OG-96-006

WCAP-14040-NP-A
Project Number 694

Subject: Westinghouse Owners Group
Transmittal of Report: WCAP-14040-NP-A, Revision 2 [Non-Proprietary] Entitled
"Methodology Used to Develop Cold Overpressure Mitigating System Setpoints and
RCS Heatup and Cooldown Limit Curves"

Figure 2.1-1

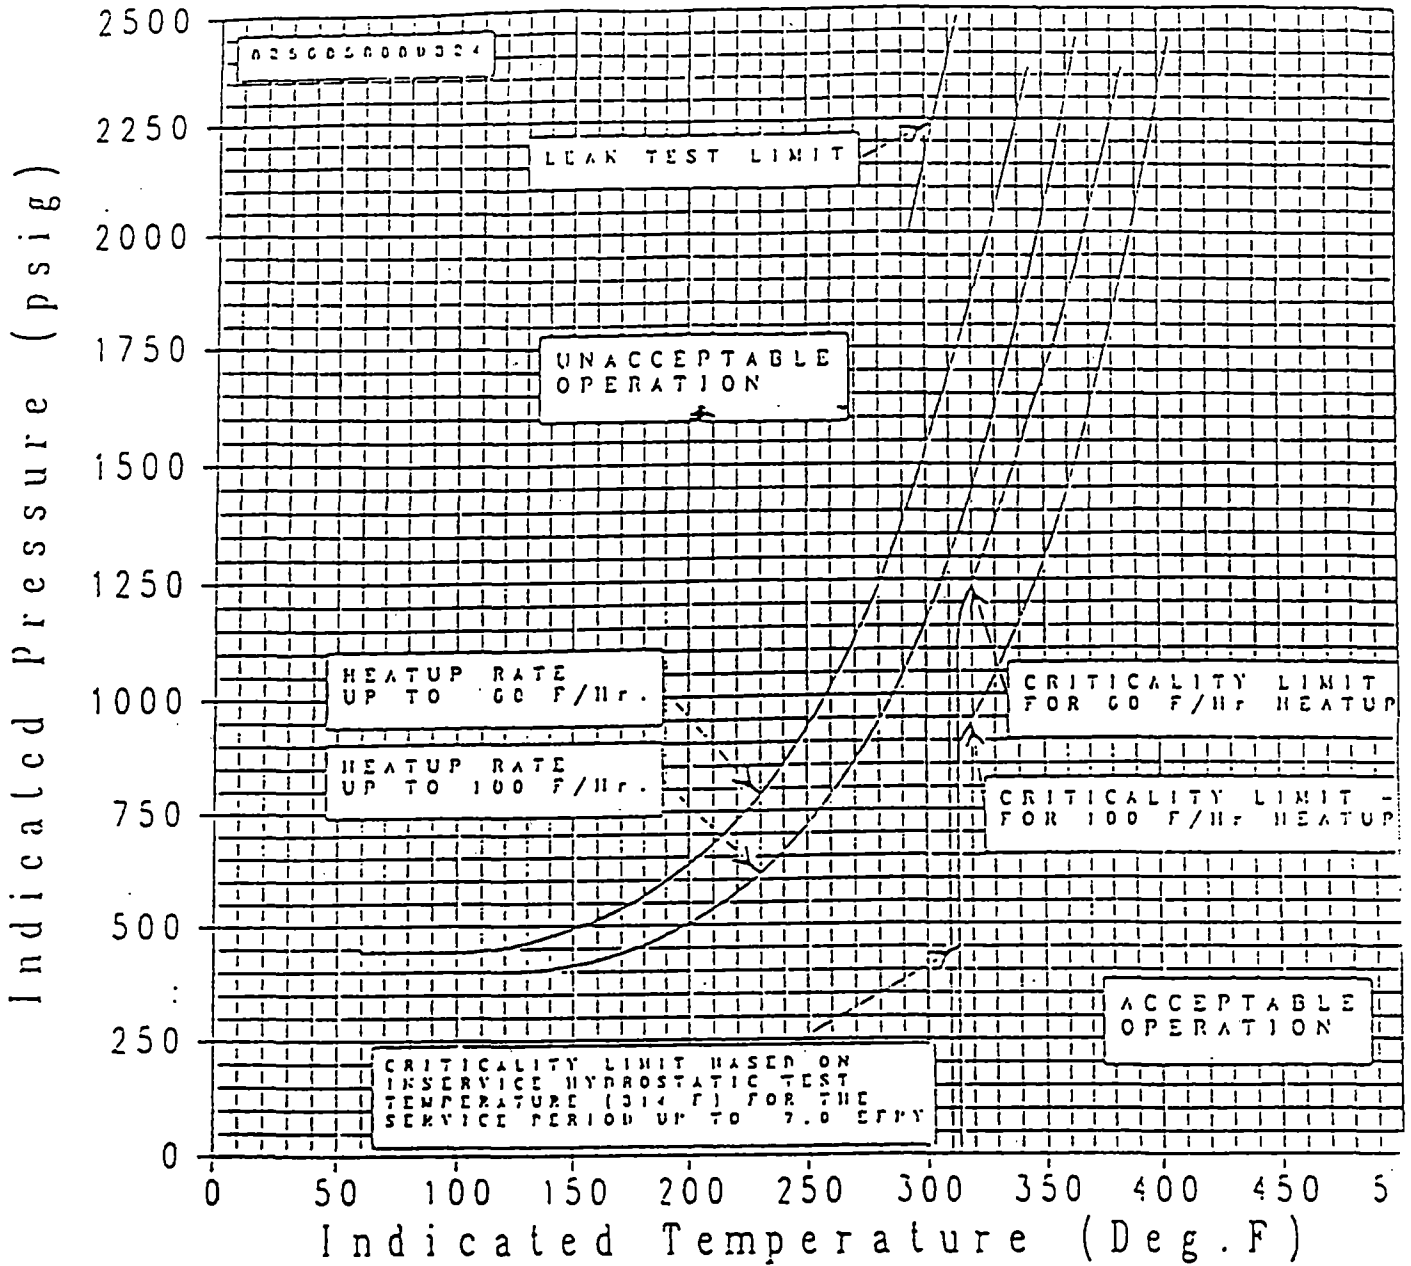
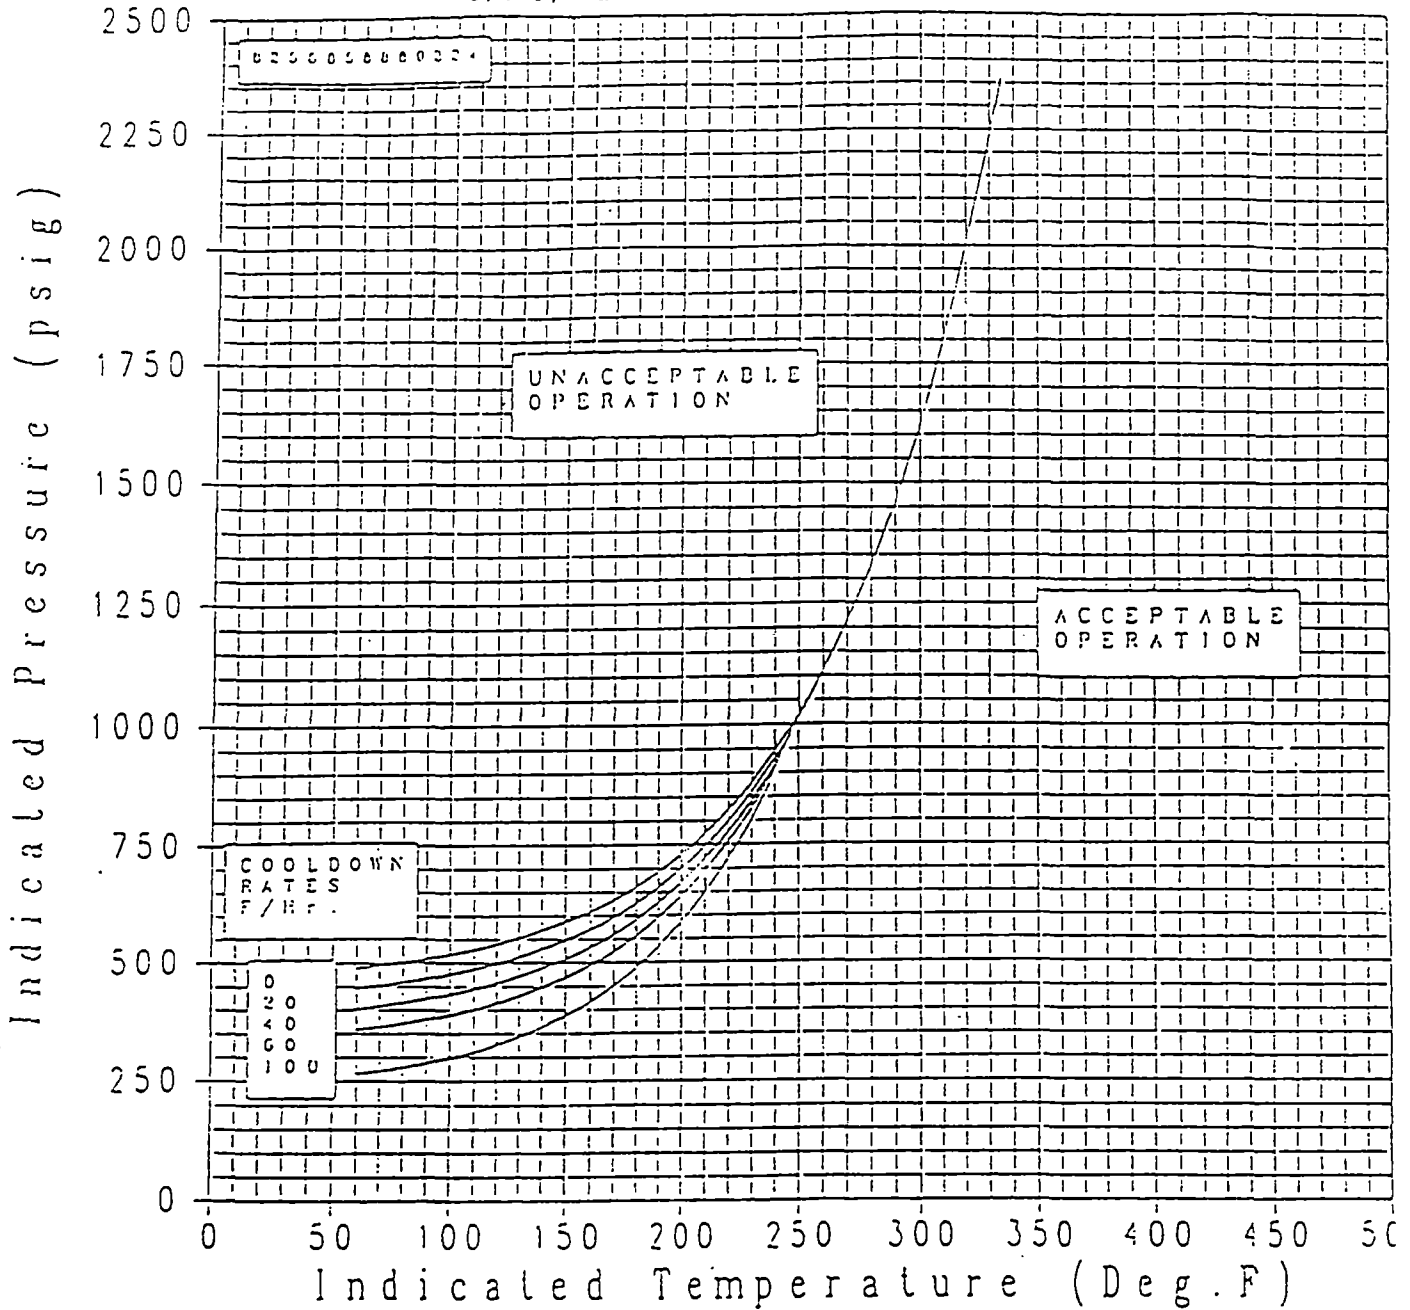
1. The pressure-temperature limits curves in Figures 1 and 2 do not include margins for pressure differences between the wide-range pressure transmitter and the limiting reactor vessel beltline region (stated on page 1). Justify the exclusion of the pressure differences for the heatup and cooldown curves.
2. On page 2, the staff requests the last sentence be revised to read "The post-irradiation fracture toughness properties of the reactor vessel beltline material will be obtained directly from the Watts Bar Unit 1 Reactor Vessel Radiation Surveillance Program."

FIG. 5—Reactor vessel cool-down limit curves. $\Delta T/\Delta t$, maximum $33^\circ\text{C}/\text{h}$ ($60^\circ\text{F}/\text{h}$) (1 psig = 6.9 kPa; 1 in. = 25.4 mm; $^\circ\text{C} = (^\circ\text{F} - 32)/1.8$).

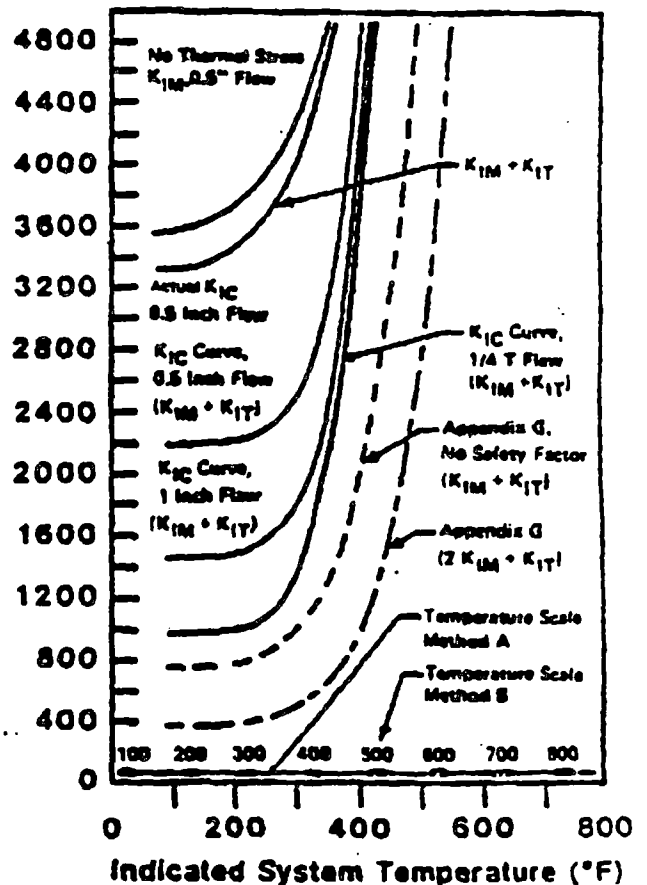
Figure 5 from Reference 2 (attached) illustrates the relative impact of the conservatisms outlined in (a) through (c), as well as their cumulative impact when applied using the Appendix G methodology.¹ Pressure/temperature limits are shown for the assumed 1/4T critical flaw size and relaxed critical flaw sizes ranging from .5 to 1 inch. When compared to lesser flaw depths in this example, the required 1/4T flaw assumption reduces allowable pressure/temperature limits by approximately 400-1200 psi at lower temperatures, where brittle fracture is of most concern. Similarly, when a factor of safety of 2 is applied to the pressure/temperature limits, the allowable pressure limit is actually based on the stress intensity resulting from a pressure twice the magnitude of the limit (e.g., an allowable pressure of 400 psig is based on the stress intensity resulting from a pressure of 800 psig).
